WATER PERMIT NO. 5803-3

Application For Permit To Appropriate Water Within The State Of South Dakota

Re: Lake Menno Dam Reconstruction - Final Review Comments
OFS #GPE931002I
GFP #W94 37 02A

RE: Final Design Documents (#1 Finals)
Repair Lake Menno Dam
Department of Game, Fish & Parks
Menno, South Dakota
OFS No. GPE931002I
GFP No. W94 37 02A
BAI #7626-02

LOCATION AND VICINITY MAP

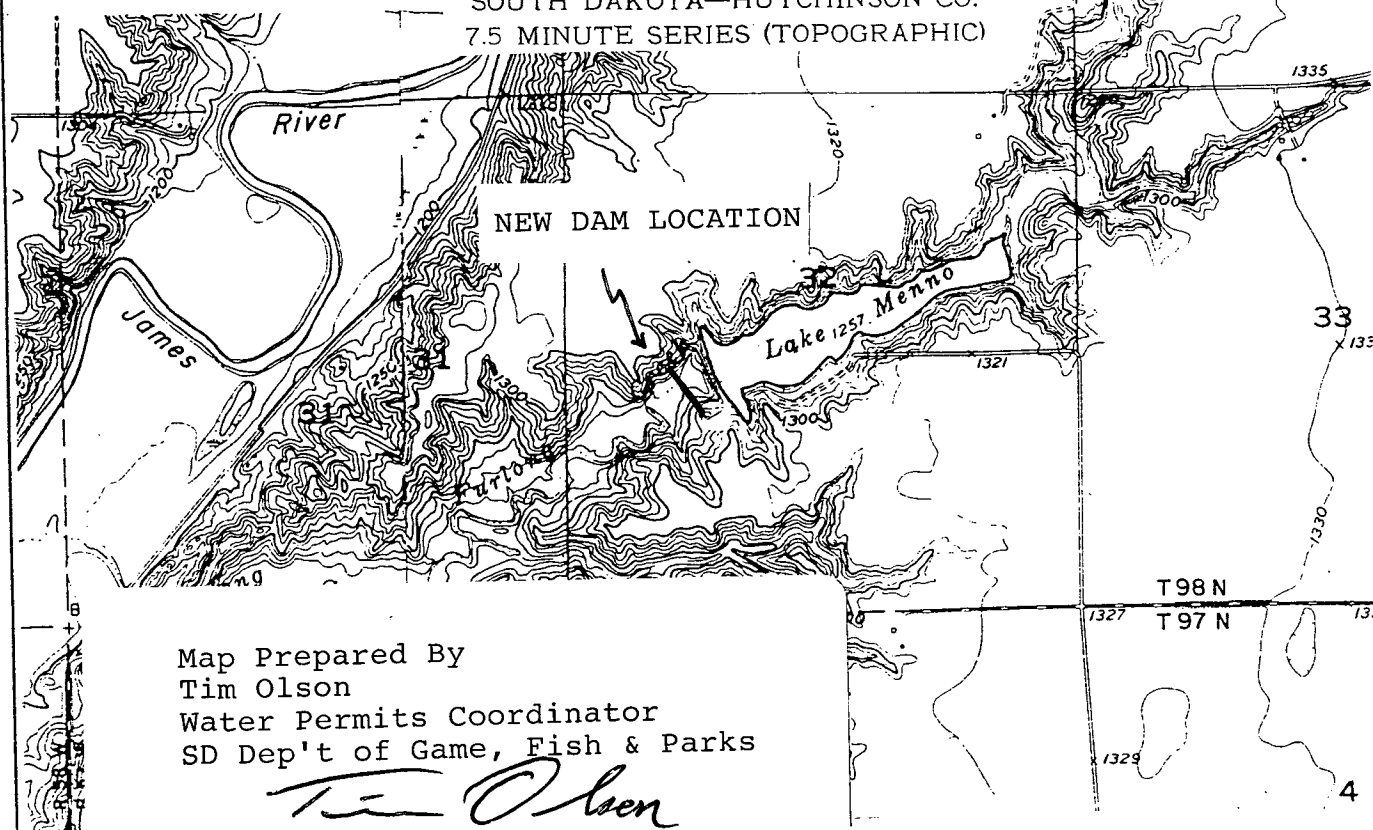
The water permit application for Menno Dam indicates the legal description of area impounded by construction of the dam to be the NE1/4, NW1/4, and the SW1/4 Section 32, T98N, R57W.

The map submitted does not show any water impounded in NW1/4 Section 32 but does show a portion on the NW1/4 SE1/4 Section 32 being inundated.

I believe the proper description of the area impounded is the N1/2 SW1/4, NW1/4 SE1/4, and S1/2 NE1/4 Section 32, T98N, R57W.

I kind of suspected that the legal desc. for the impounded water might need some refinement when I submitted the paperwork . My intention was to indicate only the quarter sections where water was to be stored - those being the NE, the NW and the SW quarter sections. After scaling off the map again, to be safe I guess we should include storage in the NW 1/4 , SE1/4. I also concur with the N1/2, SW1/4 and the S1/2, NE1/4. However, there will be impounded water in the S1/2 , NW1/4 . The reason I originally included the entire NE1/4 was to address the full service storage condition and higher "bounce" conditions which will most likely back water up into the NE1/4, NE1/4. I will stop down later with a map so we can take a look at it together. Thanks.

Tim and I sat down to discuss the area that would be impounded by the reconstruction of Menno Dam. The area of the impoundment was determined to be the NE $\frac{1}{4}$ NE $\frac{1}{4}$, S $\frac{1}{2}$ NE $\frac{1}{4}$, N $\frac{1}{2}$ SW $\frac{1}{4}$, NW $\frac{1}{4}$ SE $\frac{1}{4}$, and the S $\frac{1}{2}$ NW $\frac{1}{4}$ Section 32, T98N, R57W.

Memorandum**American Engineering Testing, Inc.**

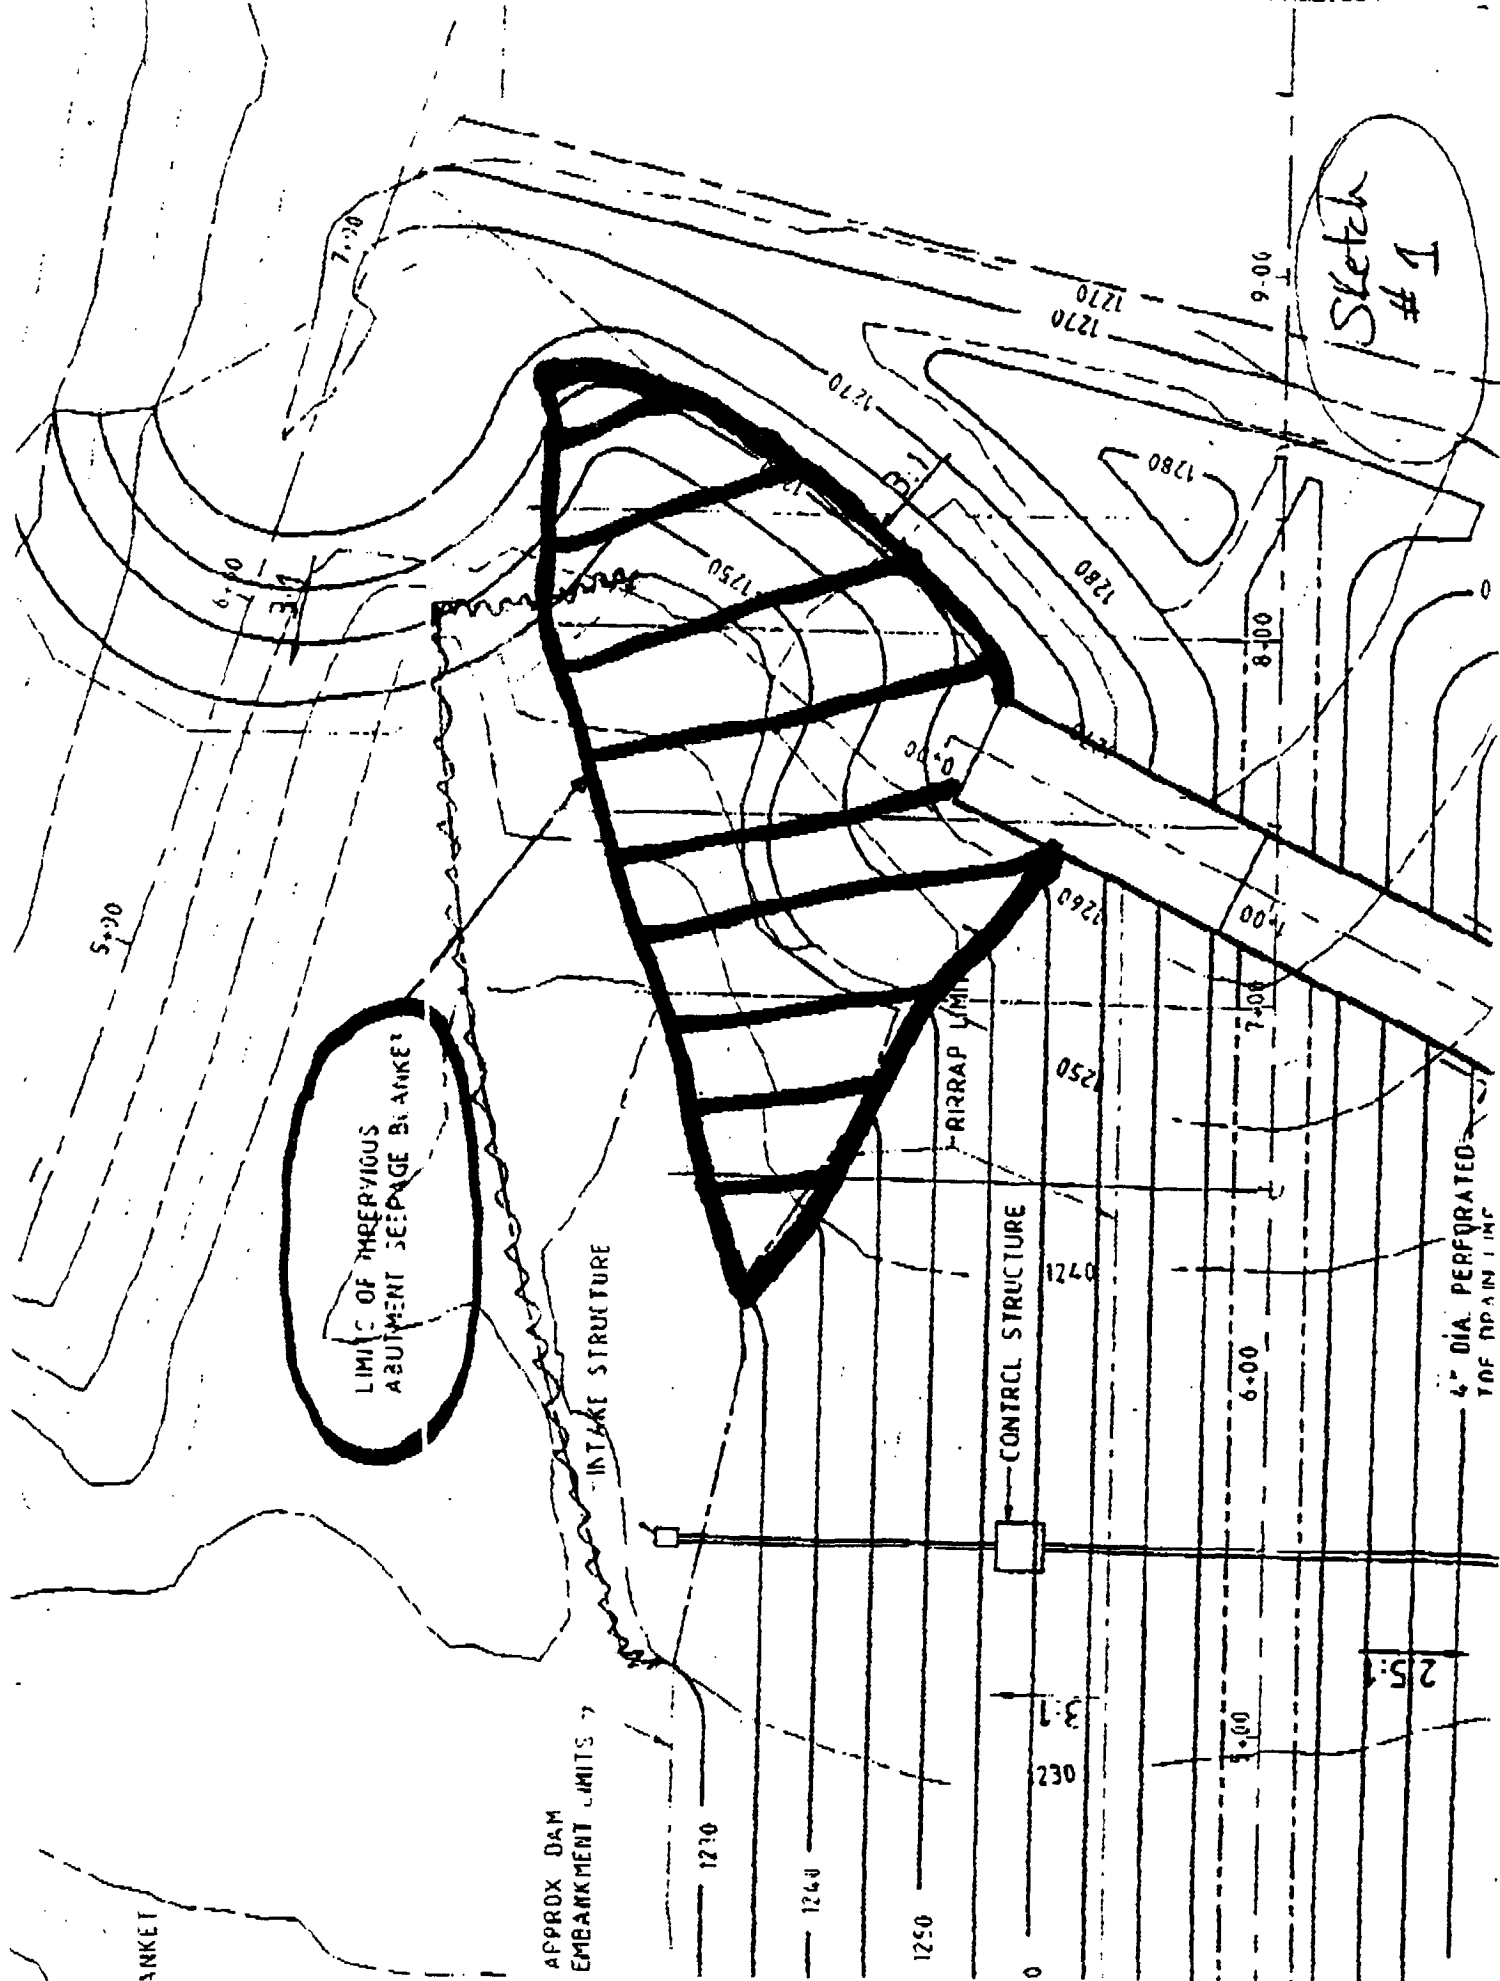
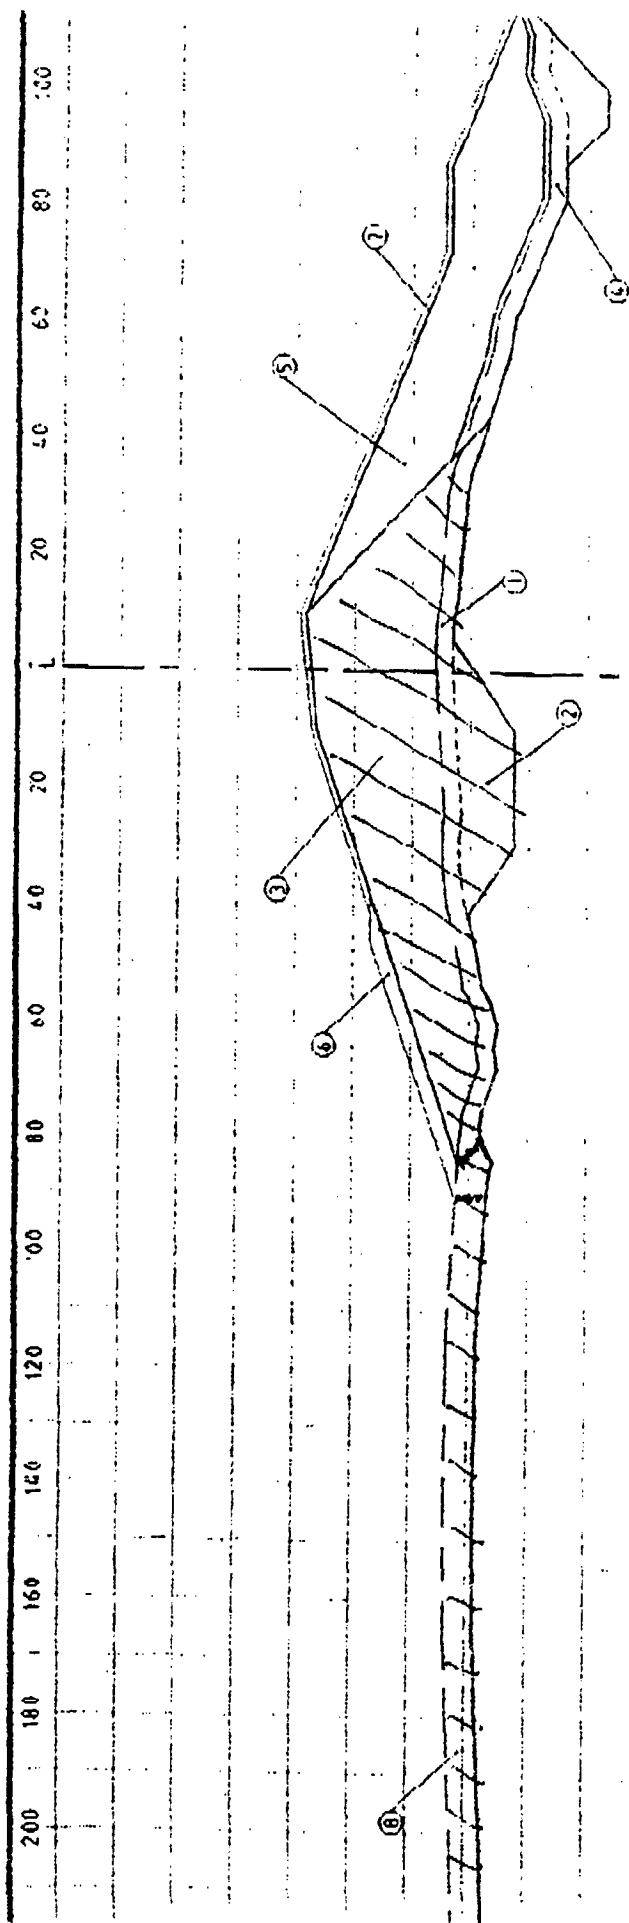
Seepage Collars On Sheet C1, the three seepage collars around the 24-inch RCP drawdown pipe should be located such that the three collars are within the impervious cutoff zone. See Sketch #7

Drainage System I recommend that the two 4-inch drainage pipes for the principal spillway be carried through the wingwall so that they can drain into the rip rap. This will provide additional protection against excess uplift pressures from developing under the chute spillway if the drainage system outlet becomes

ice jammed in winter.

The invert elevations of the 6-inch PVC drainage pipe are not shown on the plans. What is the outlet elevation of the pipes at the two toe drain headwall structures ? Please call me so we can discuss. Also is there sufficient soil cover to prevent freezing during winter ?

- ✓ 2. Revised the limits of the impervious blanket in the cross sections in accordance with review comments from Jim Rudd.
- ✓ 3. Revised the locations of the three seepage collars around the 24" RCP low level draw down pipe on plan sheet C1.

- ✓ 4. Extended the two 4" PVC drain pipes for the primary spillway through the primary spillway wingwalls to drain into the riprap.
- ✓ 5. Detailed the inverts for the 6" PVC toe drain and the 4" PVC drain pipes for the primary spillway on plan sheet B3.
